**KAWARTHA PINE RIDGE DISTRICT SCHOOL BOARD
PUR24-087-ITT
Clarke High School Classroom Refresh**

ADDENDUM NO. 2

Project No.: 24035
Date: May 9, 2024
Tender No.: PUR24087-ITT
Project: **RECONFIGURATION CLASSROOMS AT CLARKE HIGH SCHOOL**
Kawartha Pine Ridge District School Board

DRAWING NO:
A204

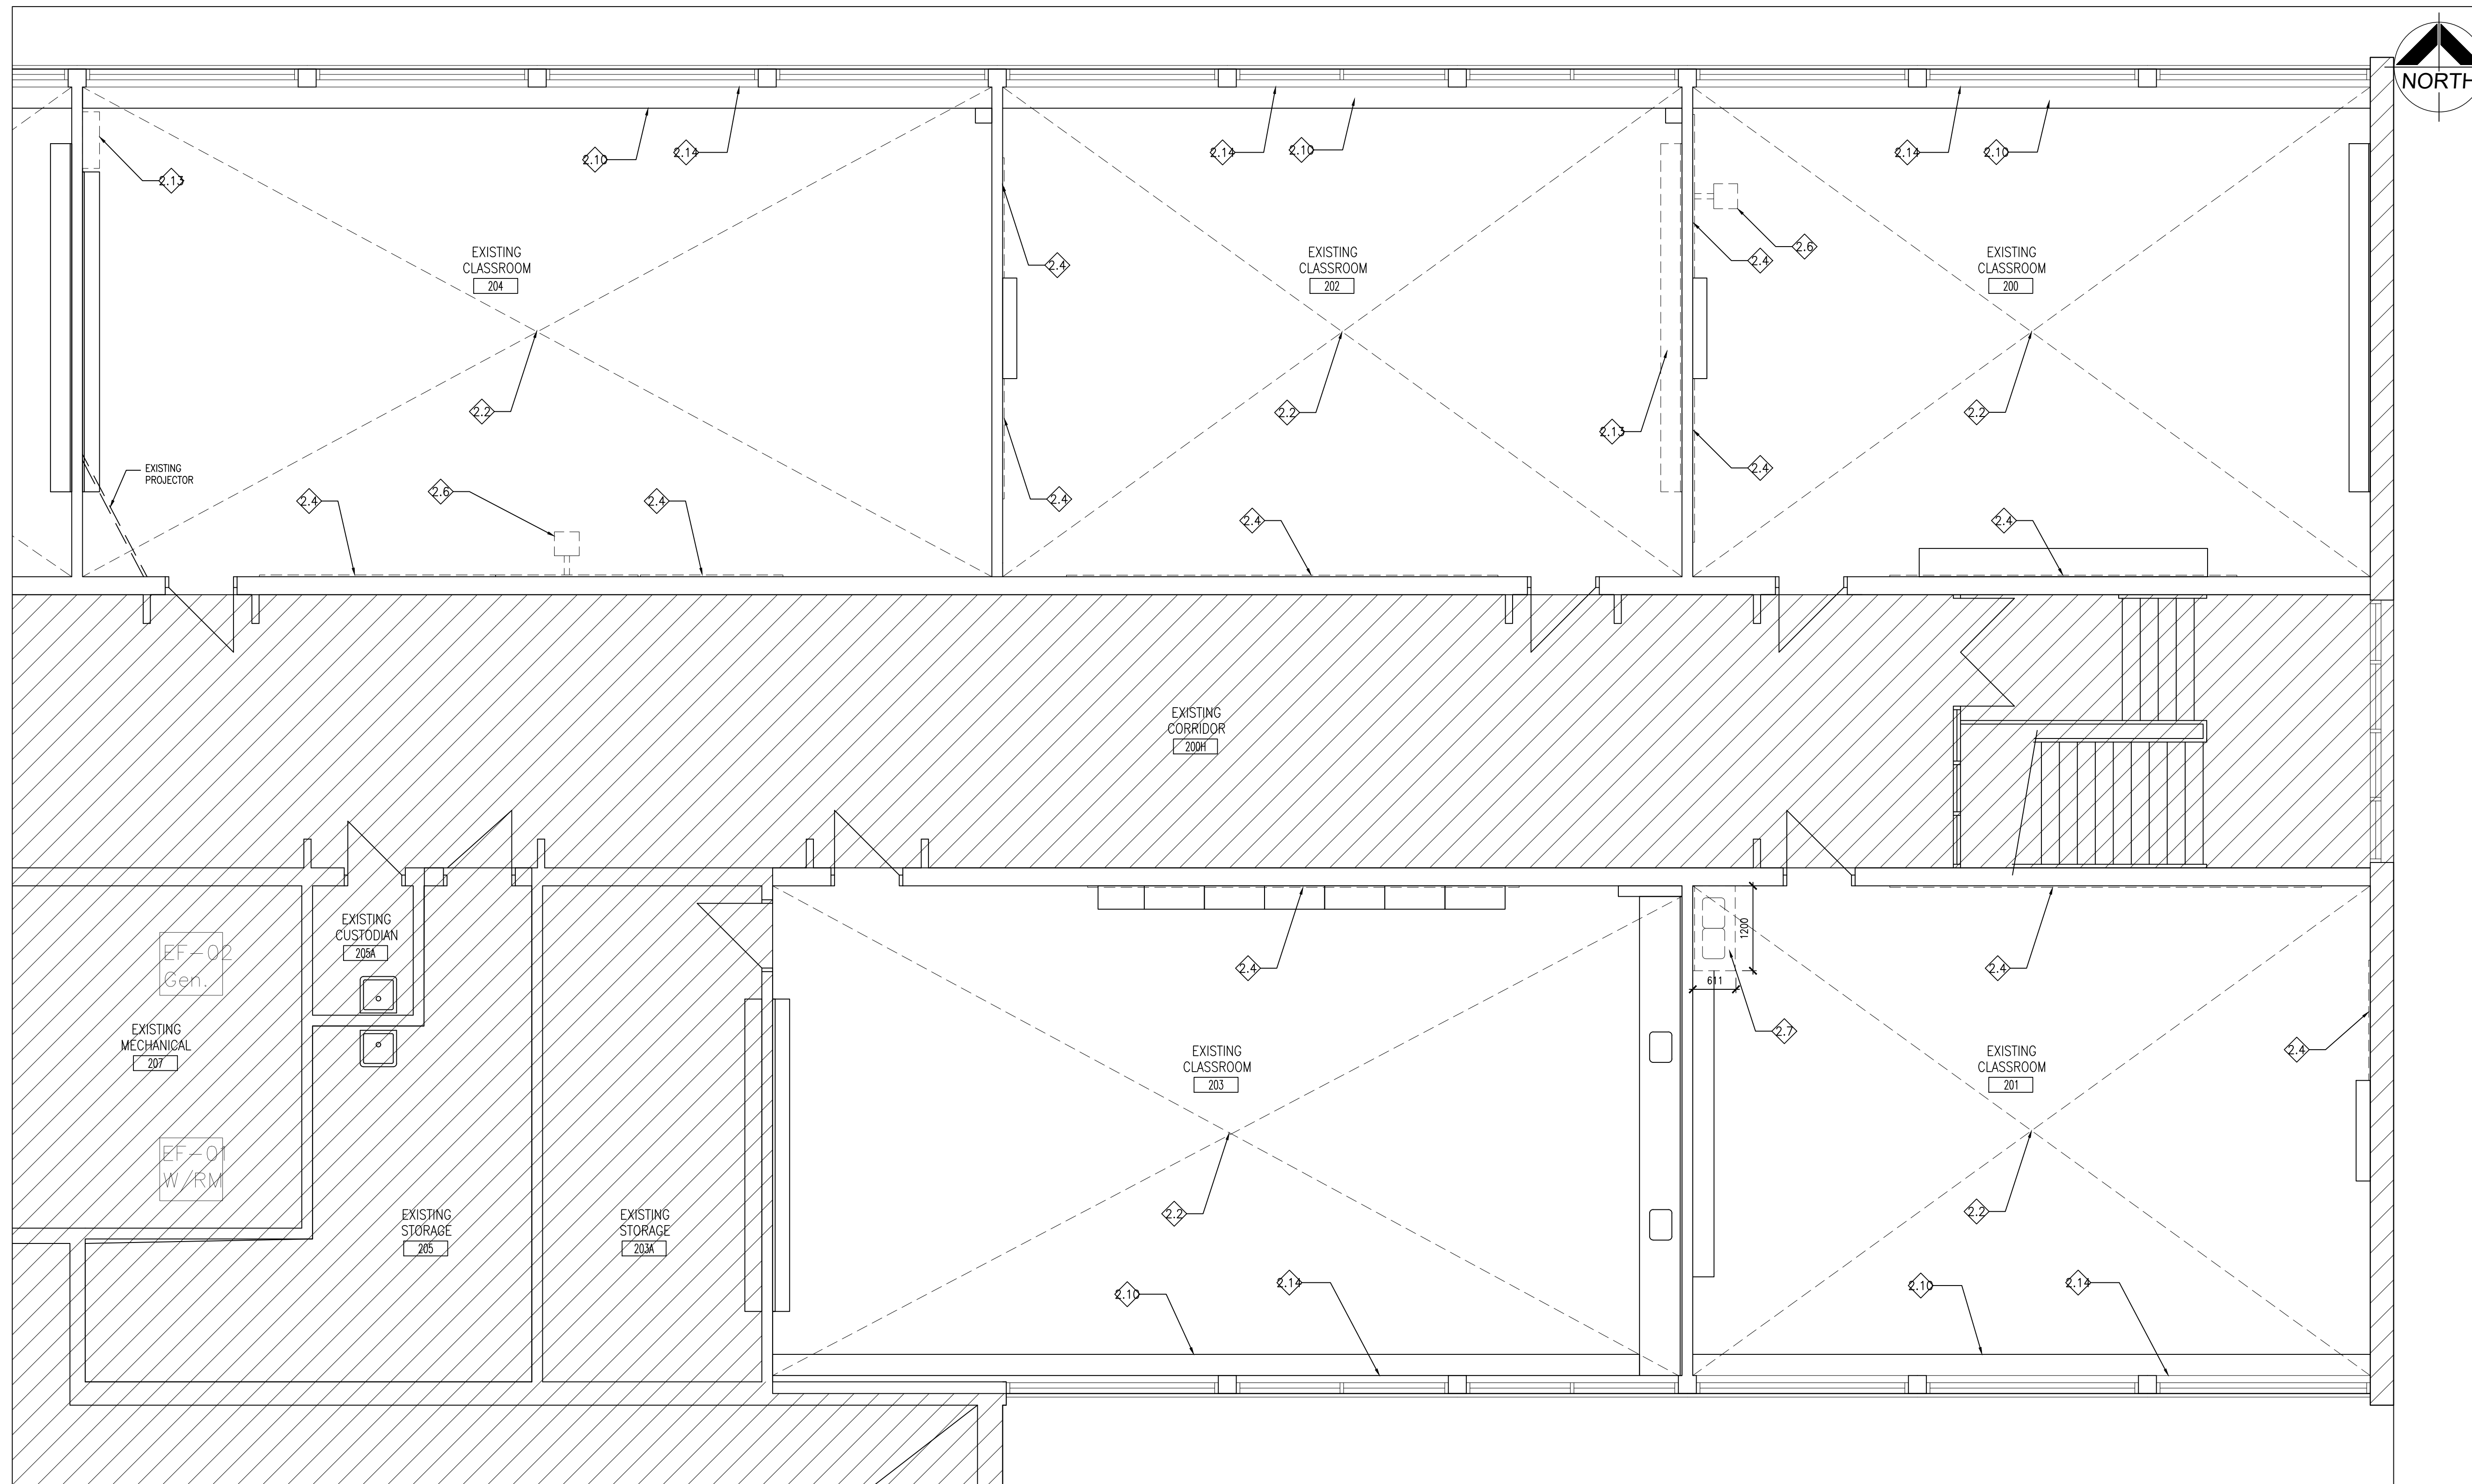
1.1 DRAWING SHEET A204 PART SECOND FLOOR DEMOLITION PLAN

- .1 Revised Note 2.13.
- .2 Added Note 2.14.

1
A207 PART FIRST FLOOR PLAN (102 & 100A)
1:50

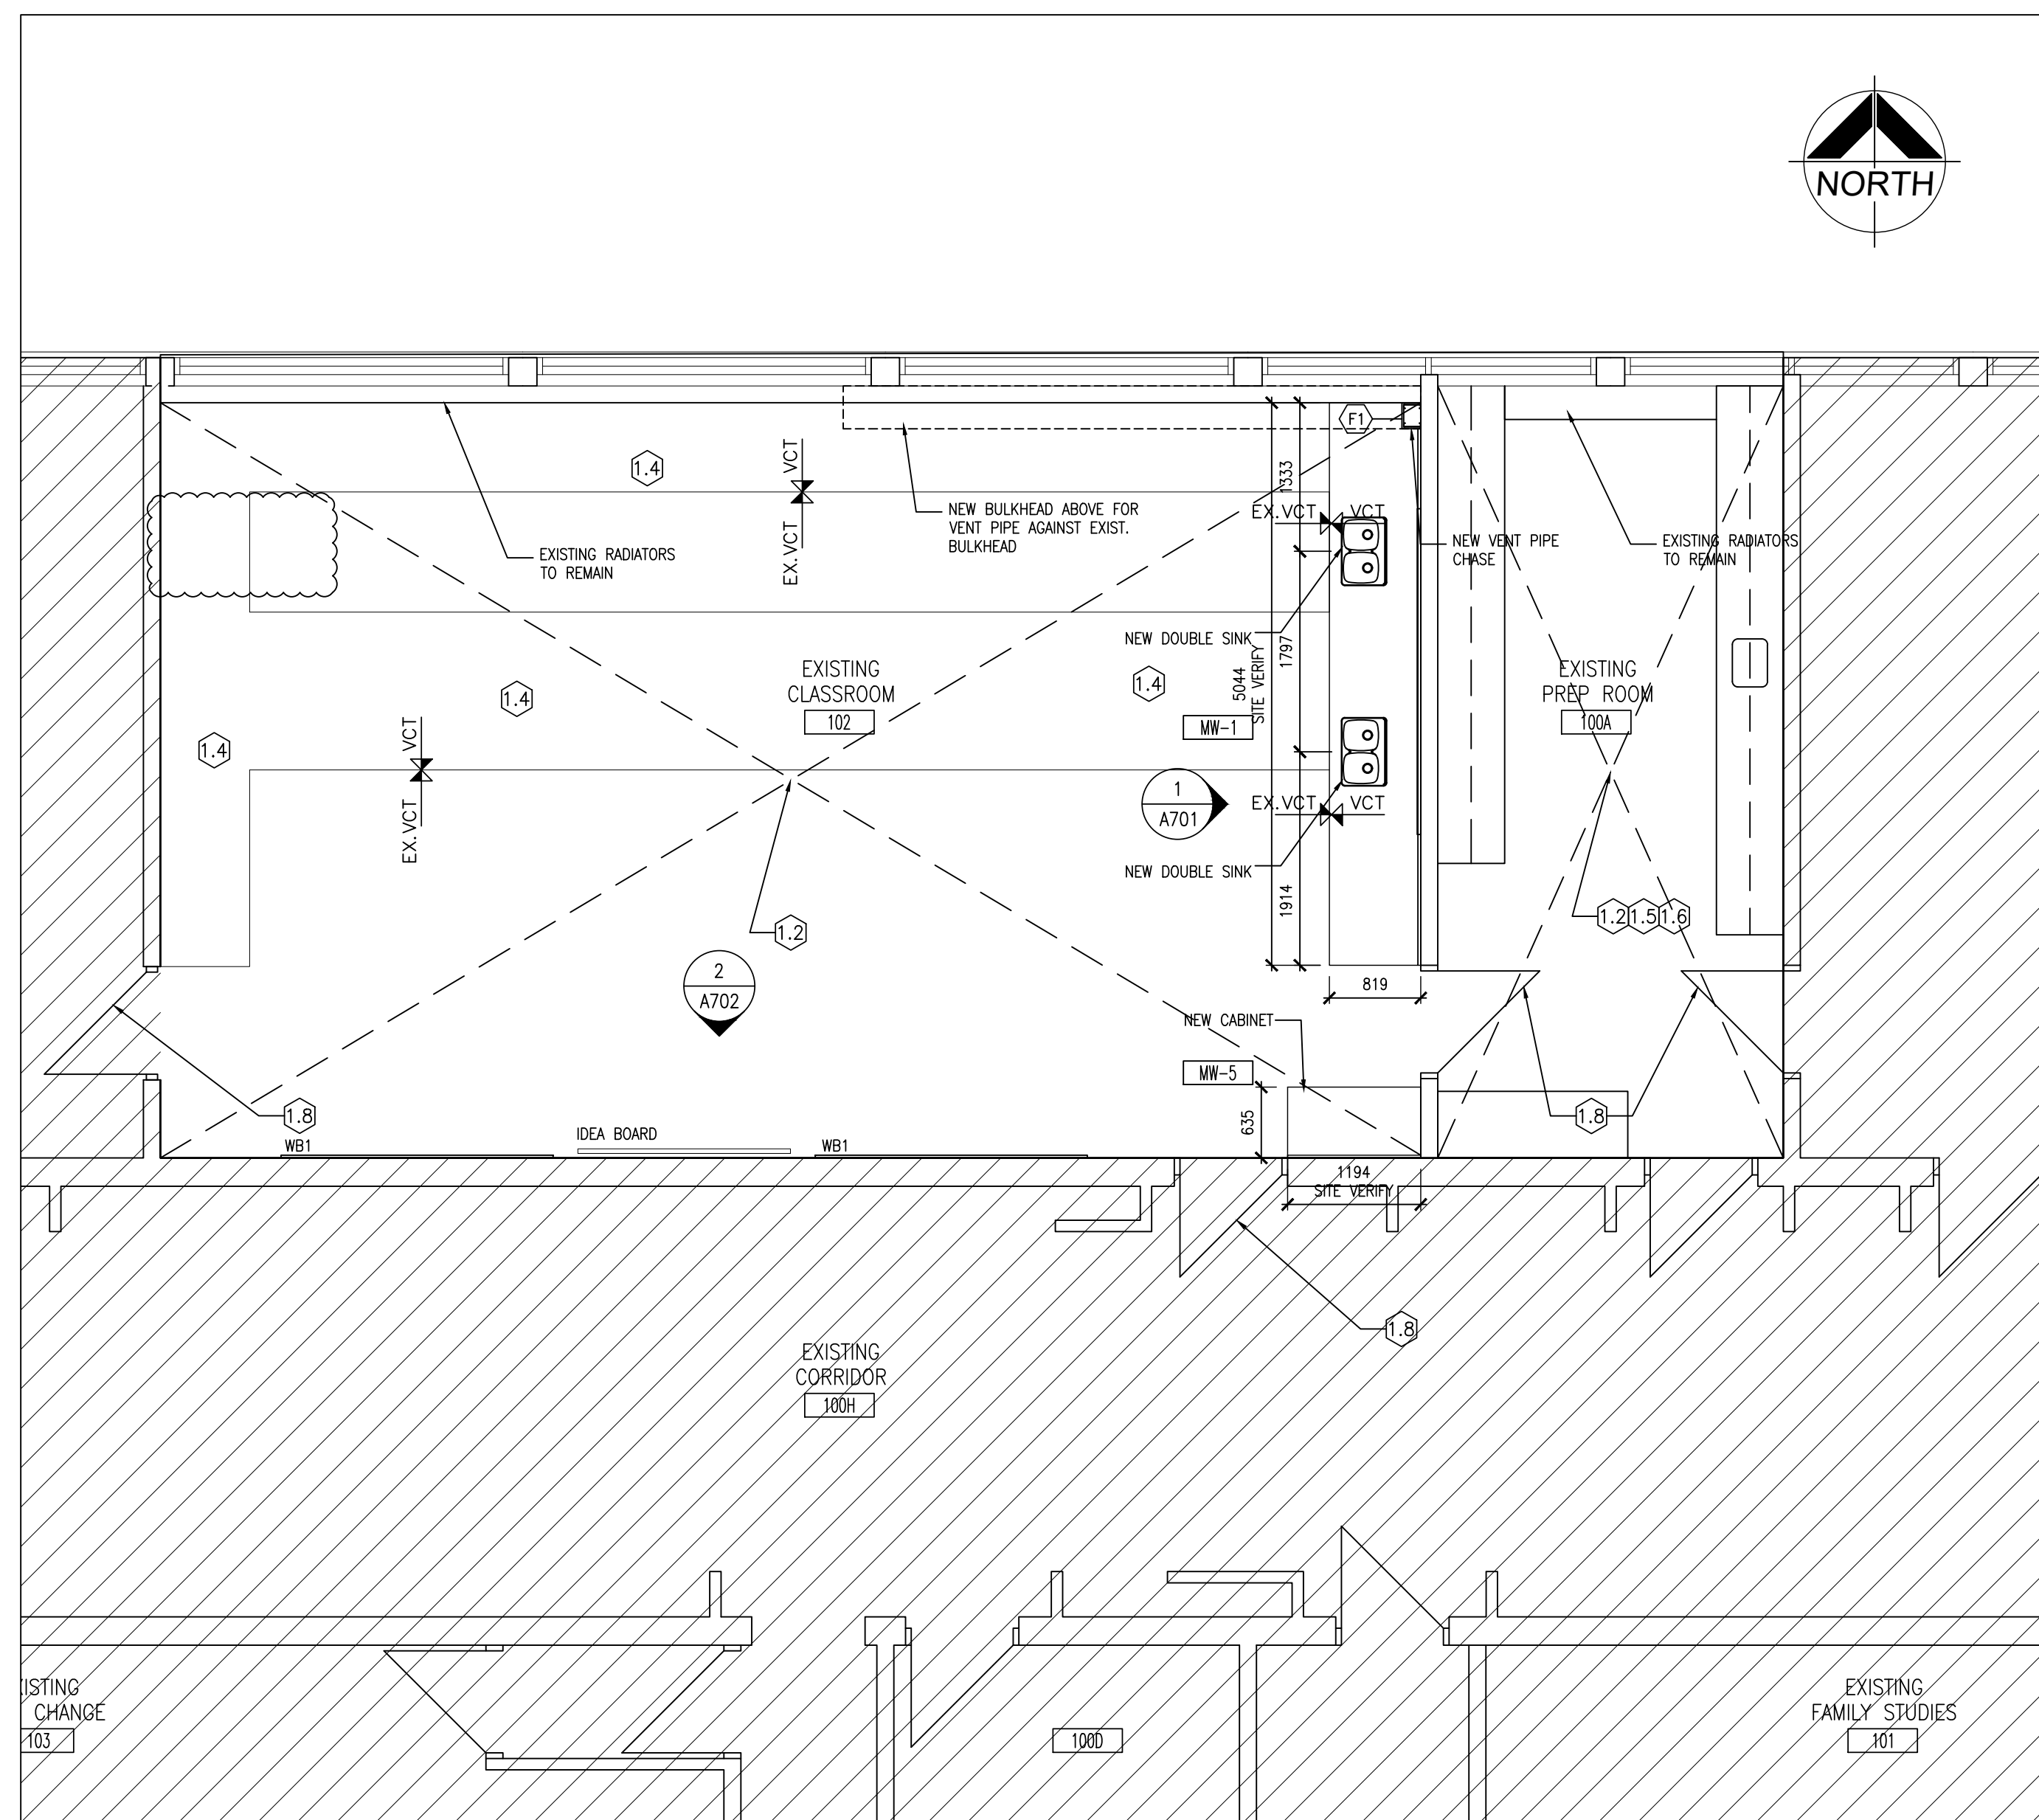
1.2 DRAWING SHEET A207 PART FIRST FLOOR PLAN

- .1 Revised extent of VCT replacement 1/A207. Provide new VCT As per plan and at locations of existing millwork.

2
A207 PART FIRST FLOOR PLAN (DOOR 100)
1:50

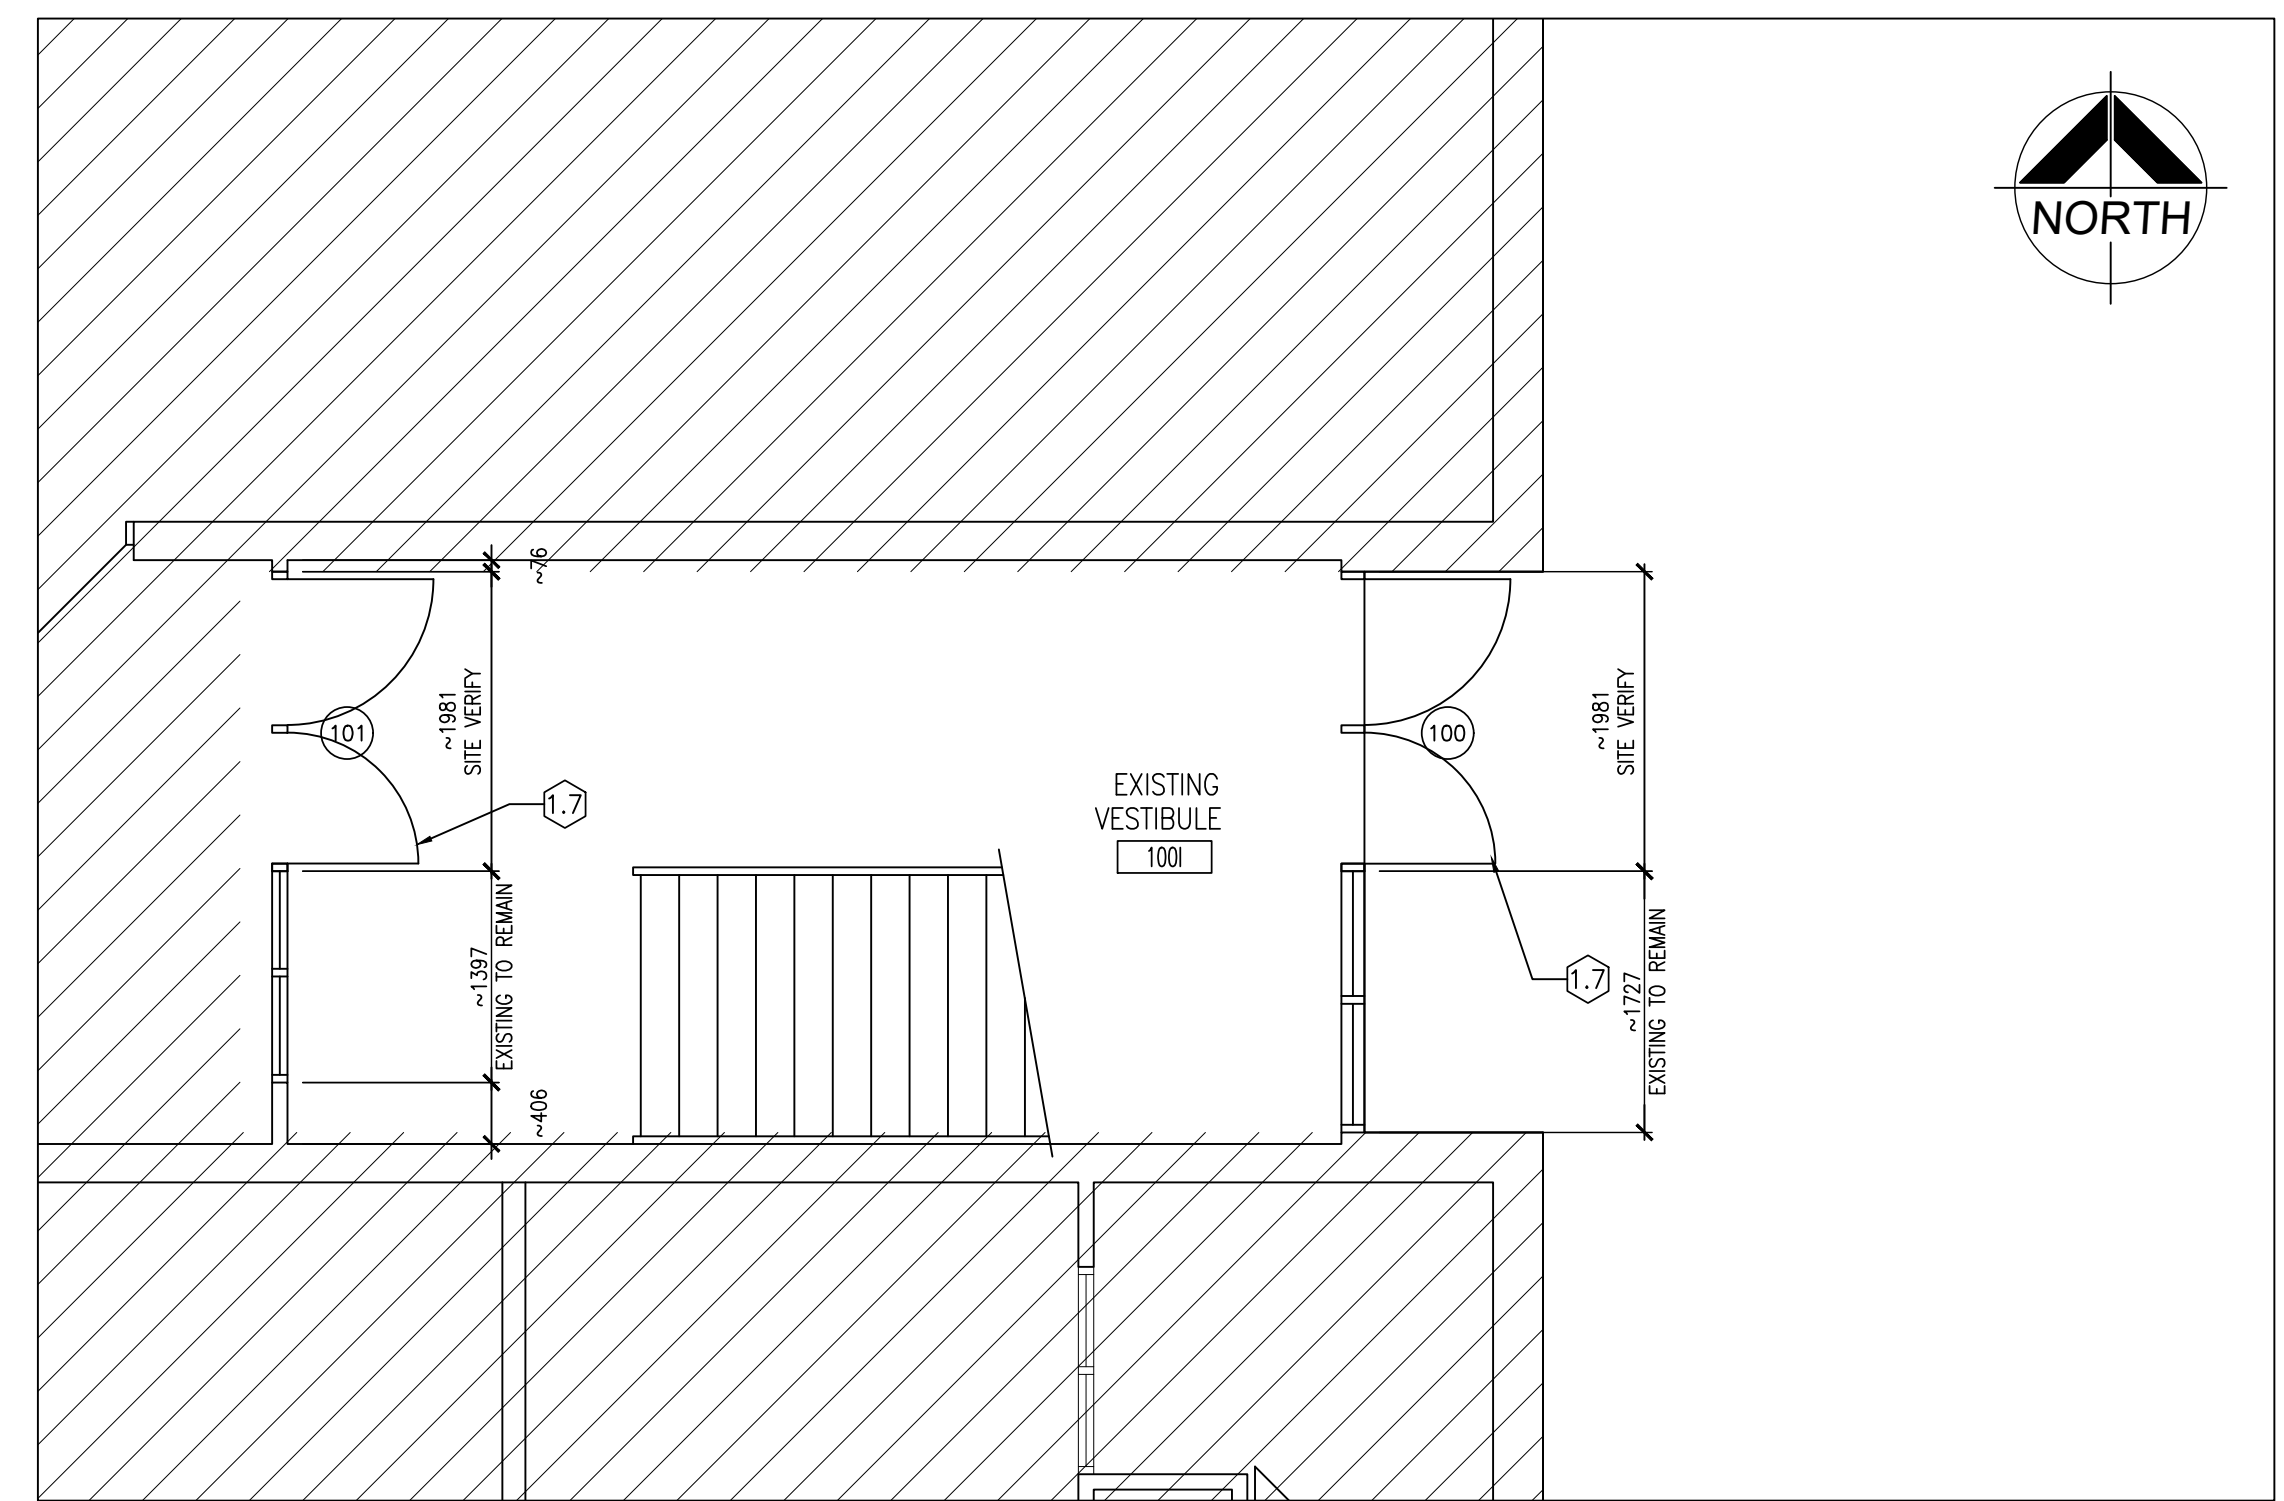
1.8 **Question:** **2/A207- states to provide new doors, demo notes to remove doors and frames. Door 101 is Hollow Metal Doors and Frames and Door 100 is Aluminum Doors and Curtainwall. Please confirm scope- are we to remove existing doors and install new doors to meet barrier free requirements and 2 new removable mullions?**

Answer: *Remove existing doors and install new doors to meet barrier free requirements with 2 removable mullions. Provide paint finish to match existing for both existing frames.*
